Reference: Engineering Services
4275 Spring Hill Church Road
Lillington, NC 27546
TE&D Project No.: 2401-0360

As requested by the client, a representative of Tyndall Engineering & Design, PA (TE&D) was on-site to observe the following items:

[NOT TO SCALE] EXISTING FOOTING ENLARGEMENT

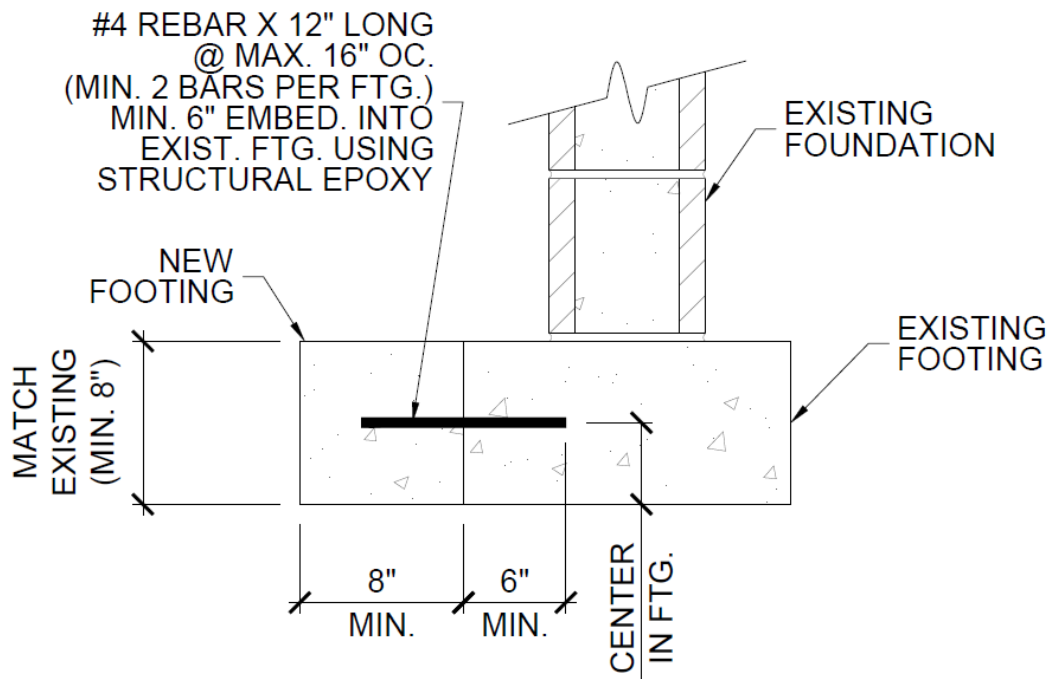
1. We observed several areas that had inadequate/missing footing projection.
Based on our observations and analysis, we recommend the footing be widened as needed per the detail on page 2 of this report.
